# AEROPLANES

## Index of Assemblies

DRG. NO. ARA4099 G/A.6 / 53

SHEET 1

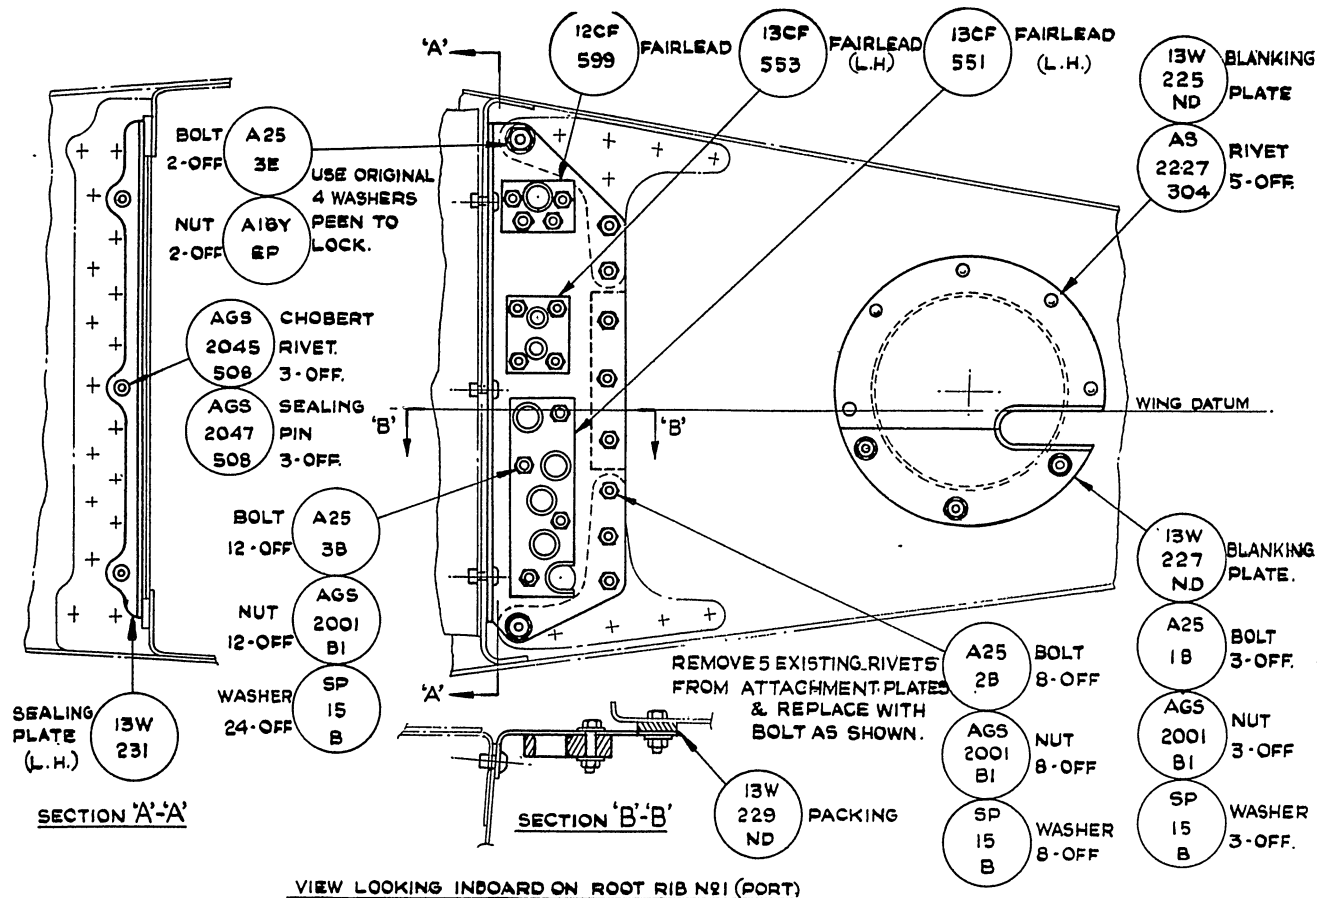
(3) Refer to Sheet 1 of the drawing; temporarily position the top half of the blanking plate, Part No. 13 W 225ND, on the outboard face of the port cone fairing support rib, as shown. With a No. 41 (0.0960 in. dia.) drill, and using the existing holes in the blanking plate as guides, drill five holes through the support rib. Retaining the plate in this position, offer up the bottom blanking plate half, Part No. 13 W 227ND, in its correct position. Using a No. 26 (0.147 in. dia.) drill, and utilizing the holes in the plate as guides, drill three holes through the rib.

(4) Remove the two plates from their temporary attachment. Deburr all of the newly drilled holes and remove all traces of metal dust. Now treat the faying surfaces of the blanking plate halves and the support rib with pigmented varnish jointing compound (Stores Ref. 33C/885), and assemble each half in its correct position, using five rivets, Part No. AS.2227/304, for the top half, and three bolts, washers and nuts, Part Nos. A25/1B, SP.15/B and A.G.S.2001/B1, respectively, for the bottom half, as shown in Sheet 1 of the drawing.

SHEET 2

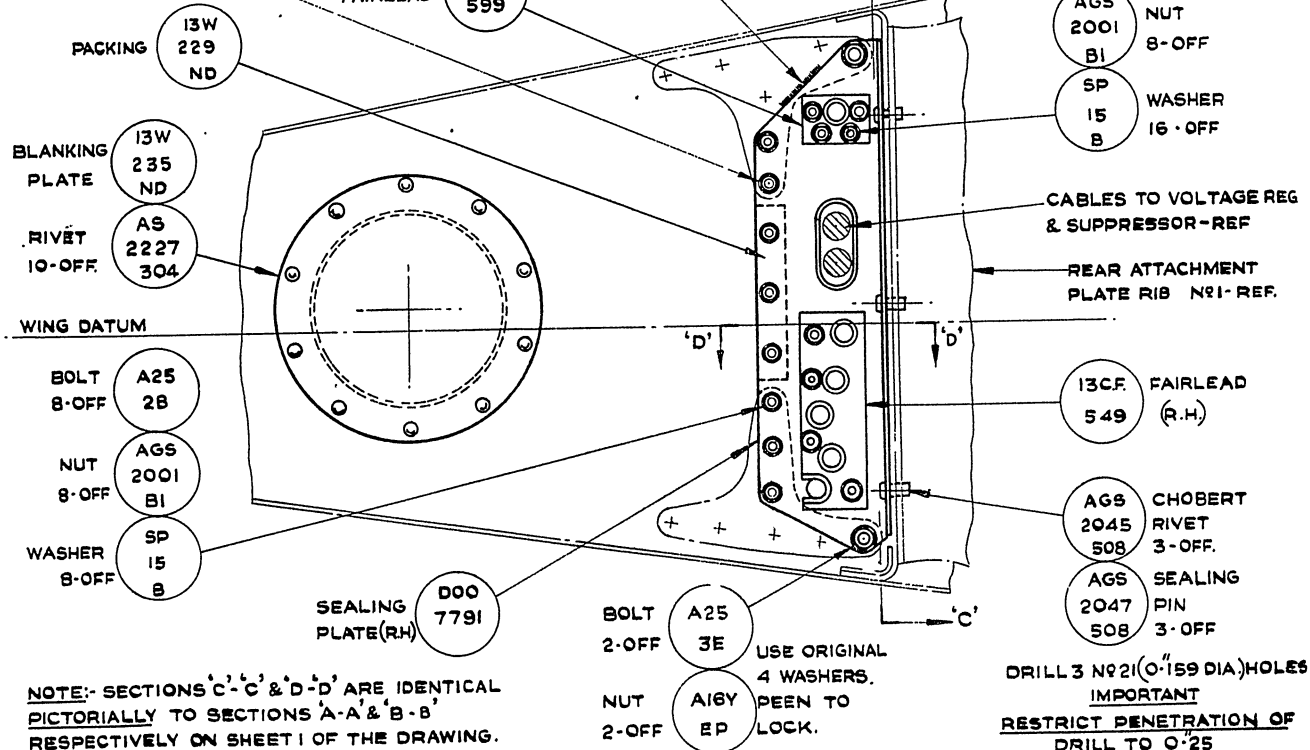
(5) Refer to Sheet 2 of the drawing, and offer up the blanking plate, Part No. 13 W 235ND, in its correct position on the outboard face of the starboard support rib, as detailed, and using a No. 41 drill (as in operation (3)), drill ten holes right through the rib. Remove the plate, deburr the newly drilled holes, and clean away all traces of metal dust. Apply a coat of pigmented varnish jointing compound to the mating surfaces of the plate and rib, and then rivet the plate firmly in position, using ten rivets, Part No. AS.2227/304.

REMOVE EXISTING RIVETS FROM ATTACHMENT PLATES & REPLACE WITH FIVE BOLTS AS SHOWN.

CUT BACK VOLTAGE REG. MTG. BRACKET (OMITTED FOR CLARITY) TO CLEAR SEALING PLATE.

SHEET 1

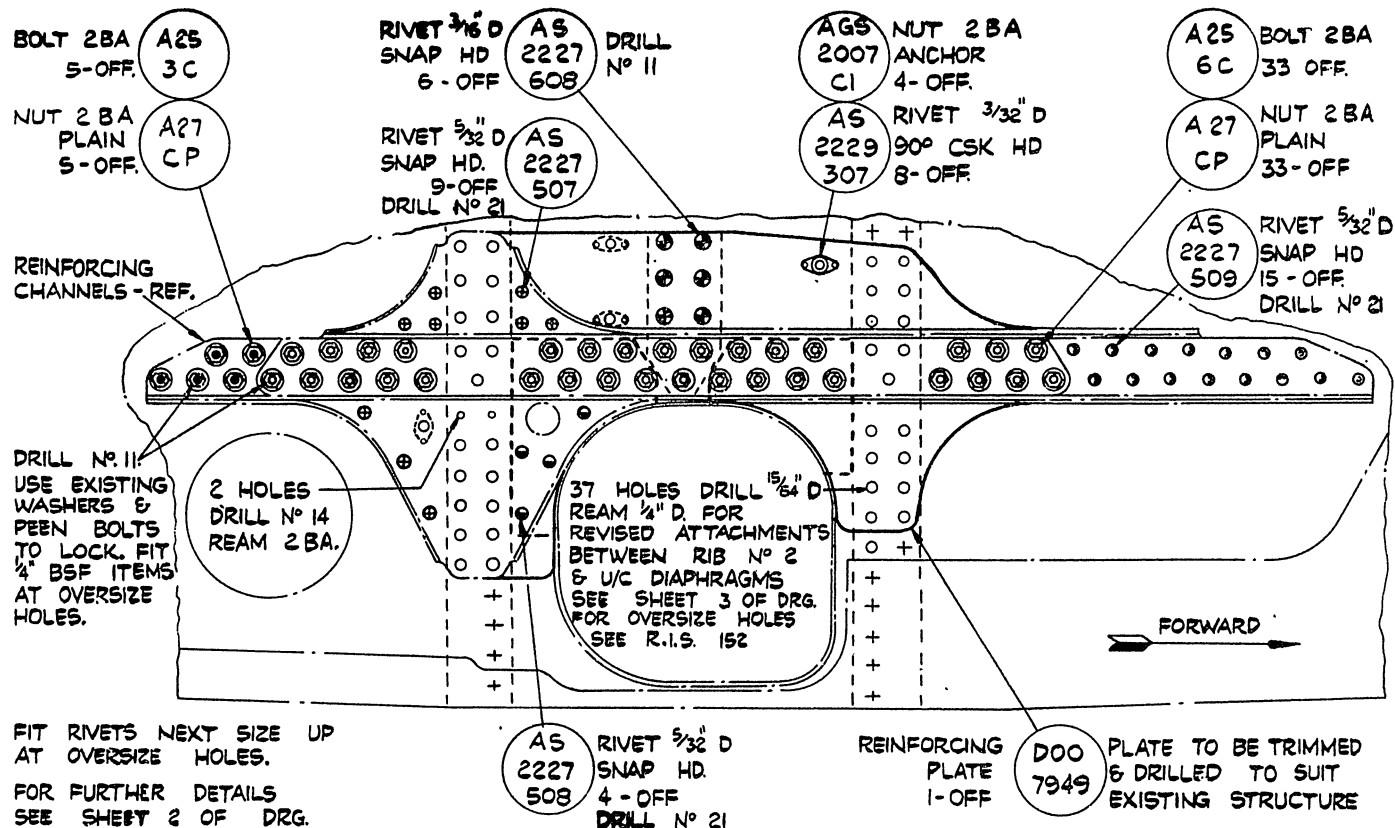
(5) *Refer* to sheet 1 of the drawing. Using the No. 41 drill, remove the existing anchor nuts that lie within the periphery of the new reinforcing plate, Part No. DOO.7949. Remove the six  $\frac{3}{16}$  in. dia. rivets securing the 'T' section stiffener to Rib No. 2 above the undercarriage cutaway using a No. 11 (0.191 in. dia.) drill. Offer up the new reinforcing plate, trim and radius its edge locally to suit the flange of the undercarriage cutaway.

(8) Drill thirty-six holes with a  $\frac{11}{16}$  (0-234) in. dia. drill through the new reinforcing plate to suit the  $\frac{1}{4}$  in. B.S.F. bolt holes through Rib No. 2 and the undercarriage diaphragms, opening up the existing smaller diameter holes, except the two dealt with in operation (7), plus the rear hole through the front diaphragm below the new reinforcing plate as shown on sheet 1 of the drawing. Ream all thirty-seven holes to  $\frac{1}{4}$  in. dia.

(10) Drill twenty-seven holes with the No. 21 drill through the new reinforcing plates to suit the  $\frac{5}{32}$  in. dia. rivet holes through Rib No. 2 and the existing reinforcing channels as shown on sheet 1 of the drawing. Mark off and drill twenty-four additional holes with the No. 21 drill as shown on sheet 2 of the drawing. Remove the plates and channels and thoroughly deburr all holes.

ADDITIONAL REINFORCING PLATE ON INBOARD FACE OF RIB NO 2 (PORT DRAWN)

SHEET 3

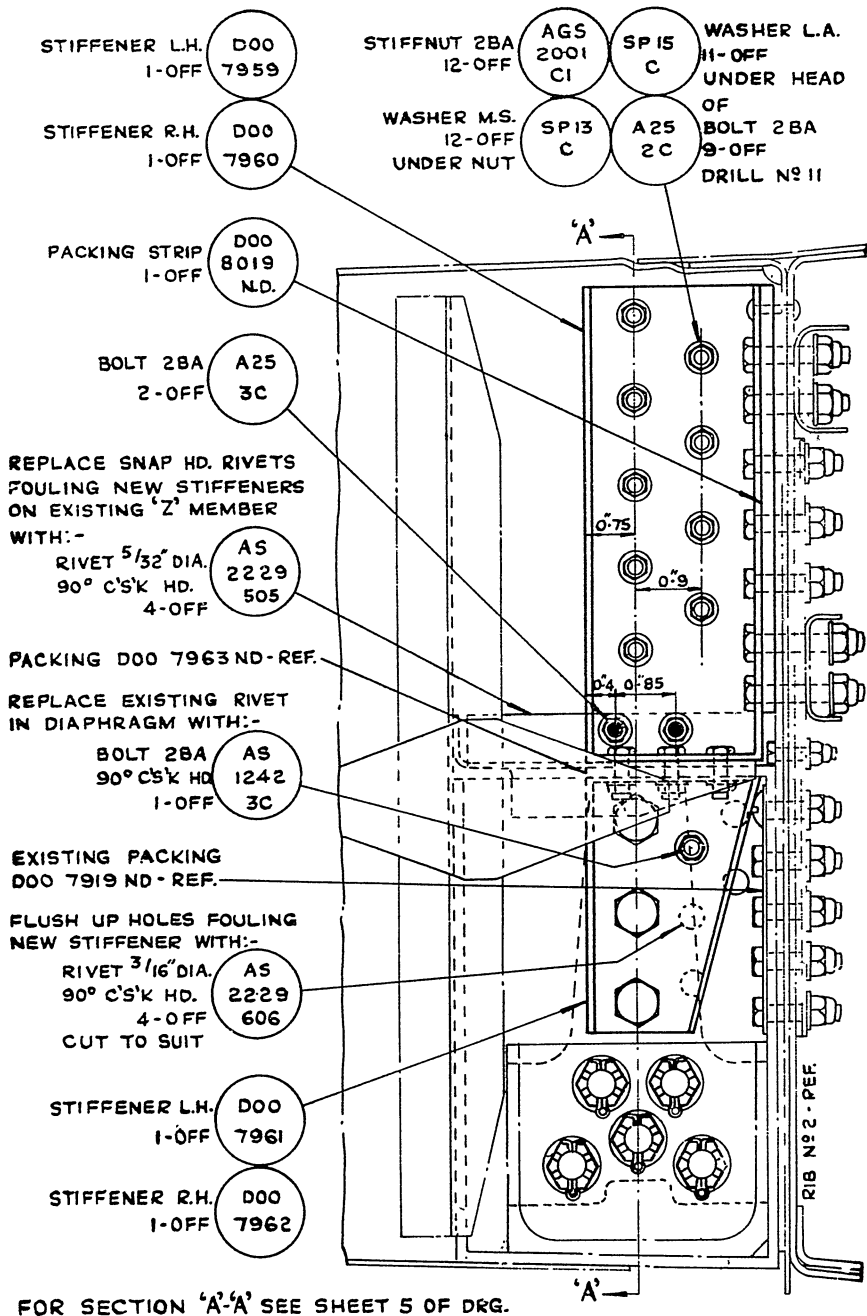
(15) Refer to Sheet 3 of the drawing. Fit two 2 B.A. bolts, Part No. A.25/3C, through the rear undercarriage diaphragm and Rib No. 2, adjacent to the 'Z' member, and secure with the original 2 B.A. stiffnuts and washers. Coat all mating surfaces with pigmented varnish jointing compound.

(24) At the rear row of holes below the 'Z' member fit a new packing strip, five  $\frac{1}{4}$  in. B.S.F. bolts, stiffnuts and washers, Part Nos. DOO.7919ND, A.25/4E, AGS.2001/E1 and SP.13/E respectively, as shown on Sheet 3 of the drawing. At the forward row of holes fit four bolts, Part No. A.25/3E. Fit one bolt, Part No. A.25/6E, above the 'Z' member and trim the new packing, Part No. DOO.8019ND, to clear this bolt. Trim the new upper and lower stiffeners, Part Nos. DOO.7955 and DOO.7957 (port); DOO.7956 and DOO.7958 (starboard), as necessary to suit the diaphragm.

SHEET 4

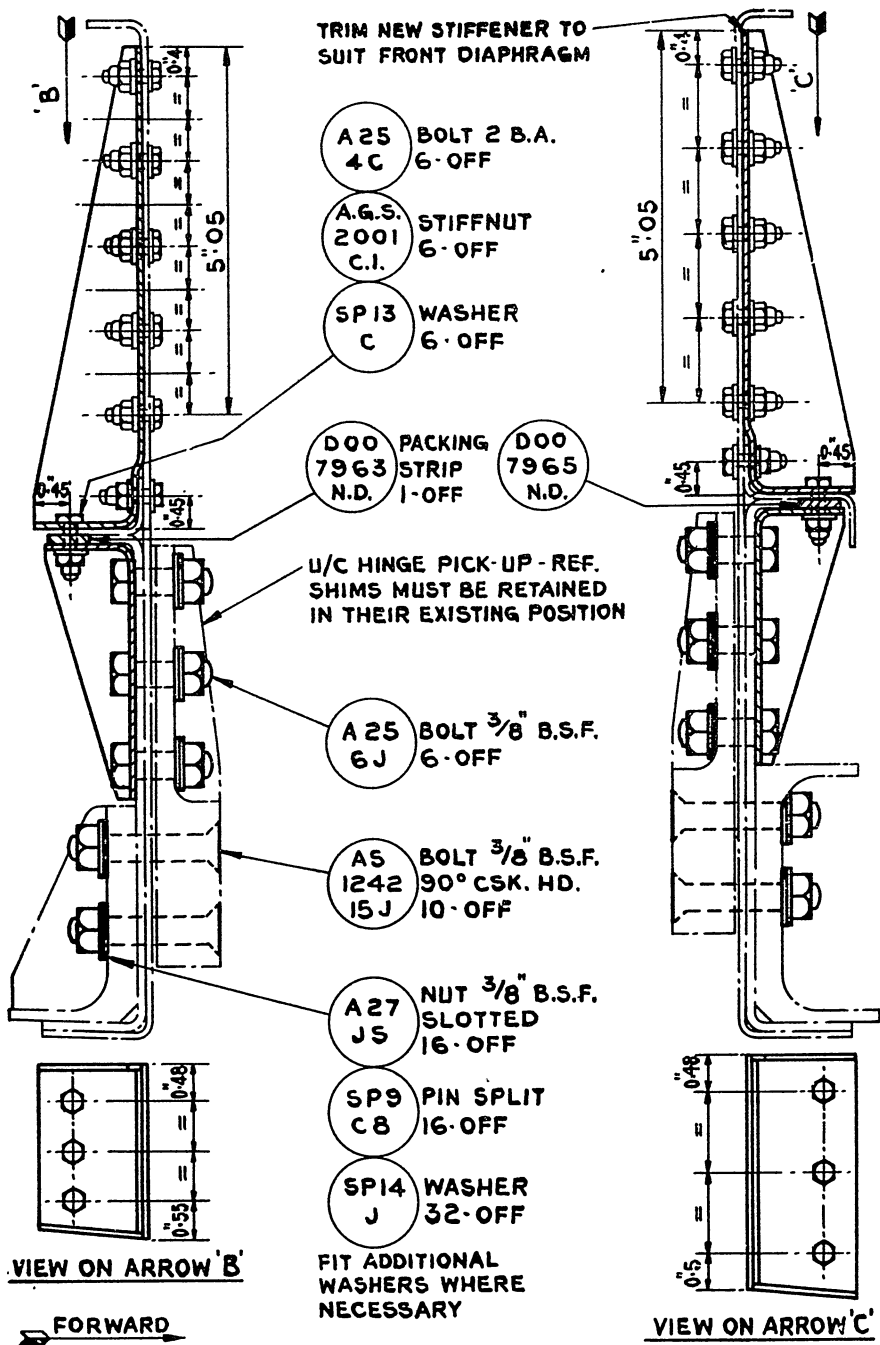
(13) Refer to Sheet 4 of the drawing. Remove the eight redundant  $\frac{3}{8}$  in. B.S.F. bolts, nuts and washers securing the undercarriage hinge pick-up to the rear diaphragm. Remove the upper two 2 B.A. bolts, nuts and washers and, using the No. 11 drill, remove the existing three  $\frac{3}{16}$  in. dia. rivets to permit the new lower stiffener, Part No. DOO.7961 (port); DOO.7962 (starboard), to fit flush against the diaphragm. Countersink the rear face of the diaphragm at the two 2 B.A. bolt holes and the lower two rivet holes 90 deg.  $\times$  0-33 in. dia. Flush up these holes with four  $\frac{3}{16}$  in. dia. 90 deg. countersunk-head rivets, Part No. AS.2229/606, cut to suit.

(17) Refer to Sheet 4 of the drawing. Offer up the new packing strip, Part No. DOO.8019ND, with a radius on one edge to suit the diaphragm above the 'Z' member. Position the new upper stiffener on the 'Z' member and against the new packing strip. Drill two holes at the top with the No. 21 drill and twelve holes with the  $\frac{11}{16}$  in. dia. drill reamed to  $\frac{1}{4}$  in. dia. to suit the existing holes through Rib No. 2 and the diaphragm flange.

(20) Remove all burrs. Refer to Sheets 3 and 4 of the drawing and secure the upper stiffener and packing to the diaphragm flange and Rib No. 2 with  $\frac{1}{4}$  in. B.S.F. bolts, six off Part No. A.25/6E, three off, Part No. A.25/7E, and three off, Part No. A.25/9E, using the original stiffnuts and washers. Fit two  $\frac{3}{32}$  in. dia. snap-head rivets, Part No. AS.2227/512, to the two top holes. Coat all mating surfaces with pigmented varnish jointing compound.

SHEET 5

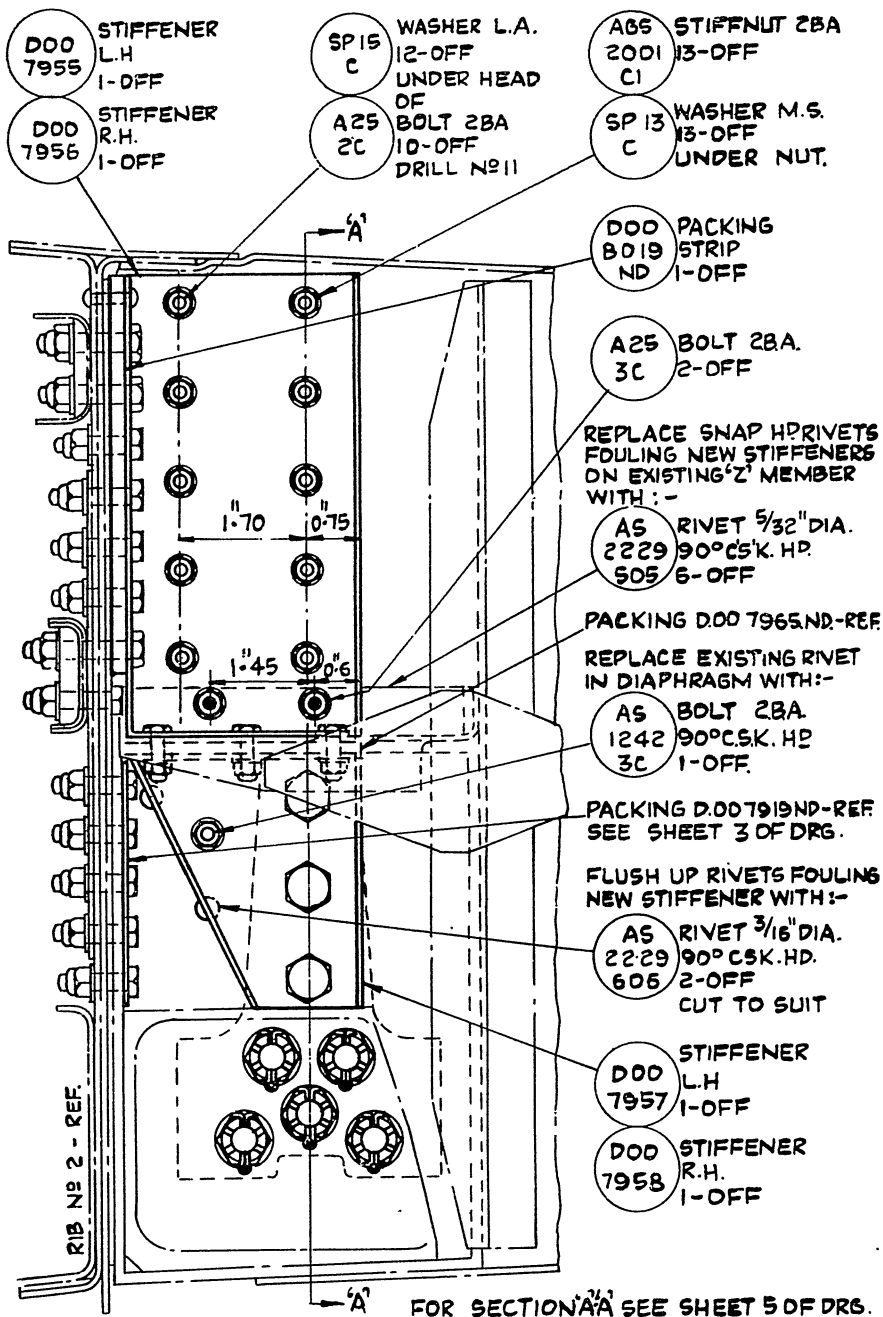
(18) Mark off and drill eleven holes through the new upper stiffener and diaphragm with the No. 11 drill to the dimensions detailed on Sheets 4 and 5 of the drawing. Position the new packing strip, Part No. DOO.7963ND, and the new lower stiffener under the 'Z' member and drill off three holes with the No. 11 drill to the dimensions detailed on Sheet 5 of the drawing. Drill one hole with the No. 11 drill through the lower stiffener to suit the existing hole in the diaphragm.

DRG. N2 A/R 4099 G / A. 7 / 56  
SHEET 7  
LP31457 9/56 625 C & P Gp. 959 (4)

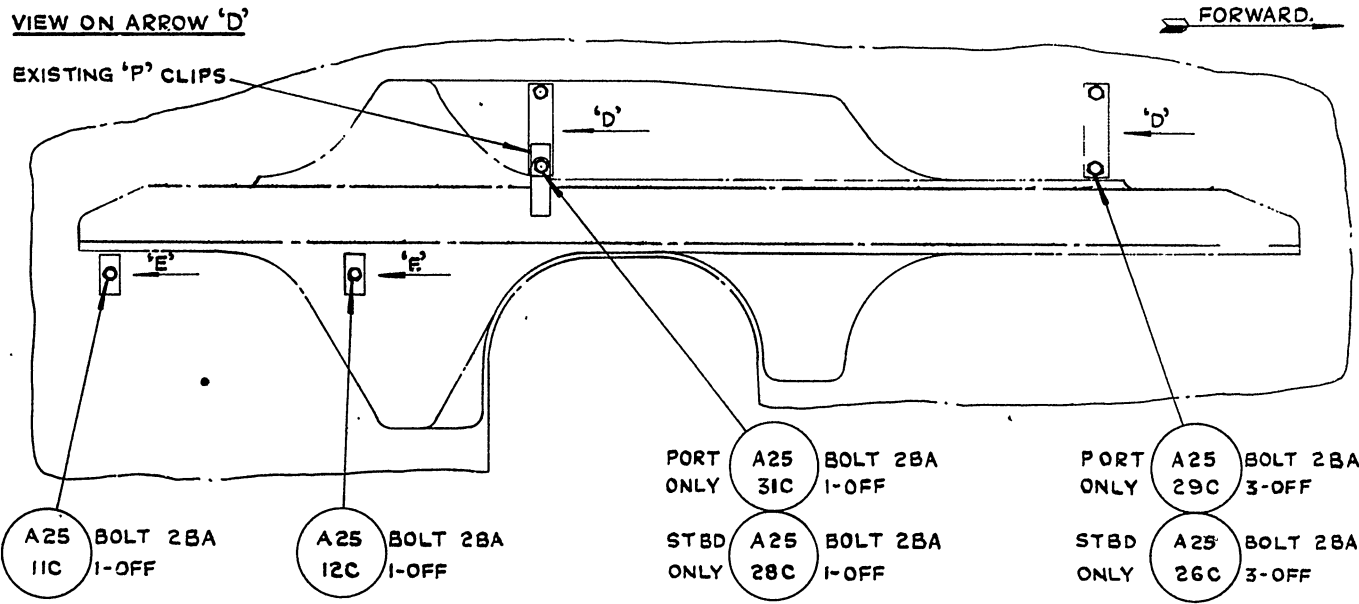
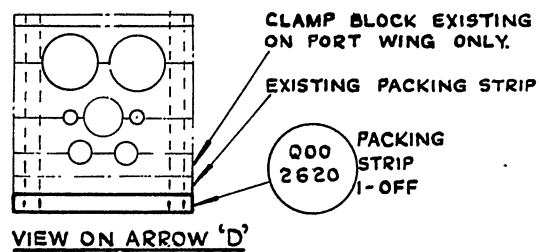
(29) Resecure the blanking plate to Rib No. 2 with its original bolts retained in operation (2). Reconnect the pipes disconnected in operation (2). Refer to Sheet 7 of the drawing. Fit an additional packing strip, Part No. QOO.2620, under the two large clamp blocks and secure the blocks and pipes to Rib No. 2 using three new 2 B.A. bolts, Part No. A.25/29C (port); A.25/26C (starboard), and also secure the cable 'P' clips with one new 2 B.A. bolt, Part No. A.25/31C (port); A.25/28C (starboard). Fit a new packing strip, Part No. QOO.3783, in place of the redundant strip, Part No. QOO.2621 under the two small clamp blocks and secure the blocks and the pipes to Rib No. 2, with one 2 B.A. bolt at the rear position and one at the forward position, Part Nos. A.25/11C and A.25/12C respectively. Lock the pipe couplings with 22 s.w.g. nickel alloy wire (Stores Ref. 30A/3055).

REVISED PACKING UNDER EXISTING CLAMP BLOCKS ON RIB N2 (PORT DRAWN)

SHEET 2

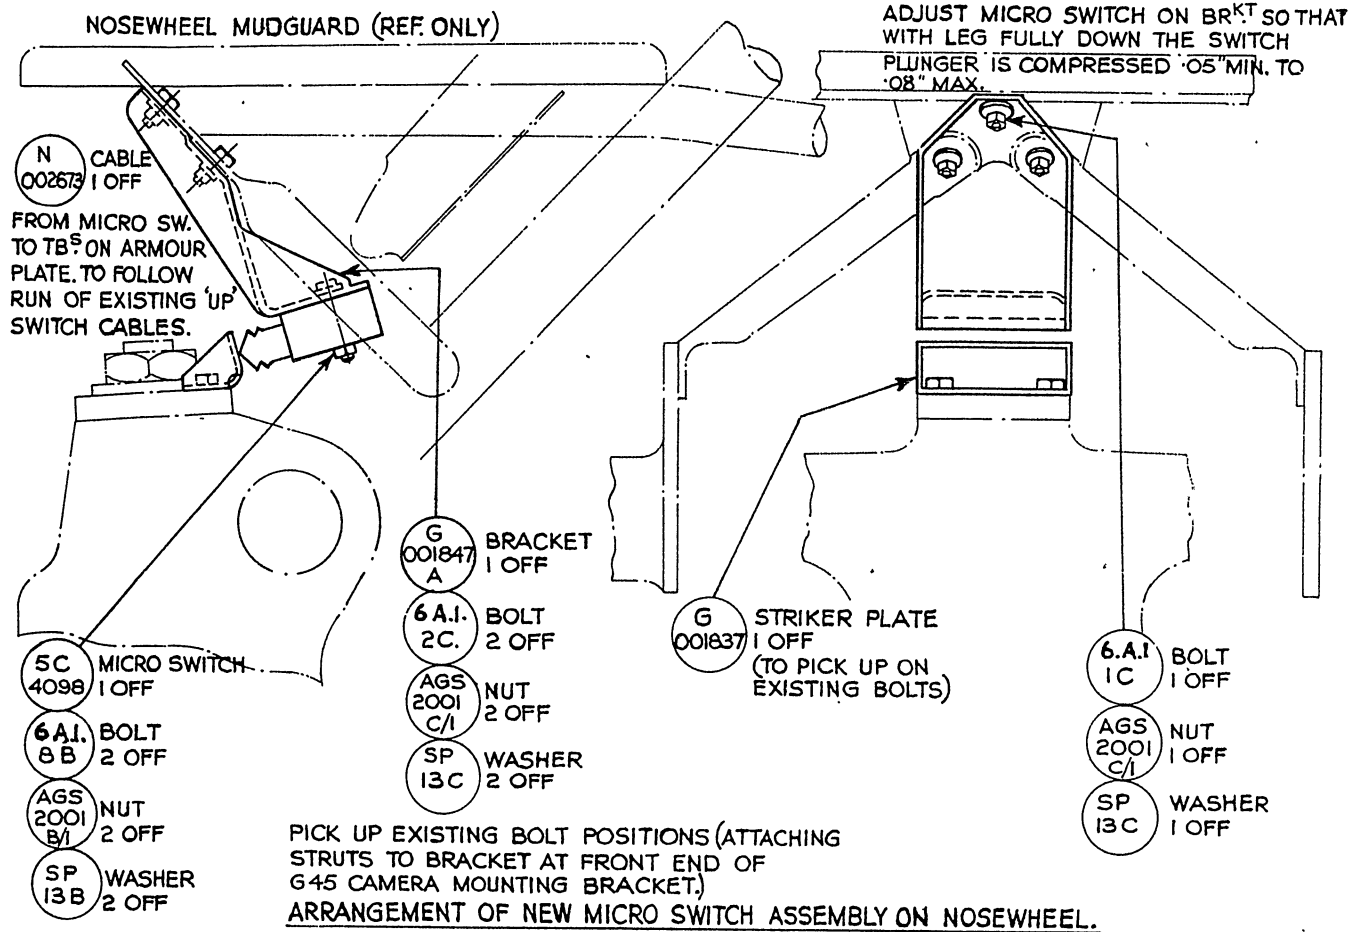
(2) Refer to Sheet 2 of the drawing, and unlock and remove the two  $\frac{1}{4}$  in. B.S.F. bolts indicated. Position the new striker plate, Part No. GOO 1837, replace the bolts and lock with 22 s.w.d. soft iron locking wire.

(3) Secure the bracket, Part No. GOO 1847, to the two bolts securing the camera mounting to its support struts. Drill a No. 11 (0.1910 in. dia.) hole through the camera support plate to pick up the remaining hole in the new bracket, and secure with a nut, bolt and washer, as shown in Sheet 2 of the drawing.

(5) Connect up the new cable, Part No. NOO 2673, to the micro-switch (Stores Ref. 5C/4098) with the coding U 10, U 14 and U 9 going to terminals A, B and C respectively. Bolt the micro-switch to the bracket, as shown in Sheet 2 of the drawing.

(8) Refer to Sheet 2 of the drawing, and disconnect all leads from the two "UP" switches situated under the camera mounting, the leg lock switch at the top of the leg structure and the two 3-way terminal blocks on the armour plate. Re-code and re-connect these cables to the switches and the terminal blocks as shown in the wiring diagram.

(15) Locate the two terminal blocks in the wheel well, disconnect all switch leads from the terminal blocks, re-code and re-connect as shown in Sheet 2 of the drawing.
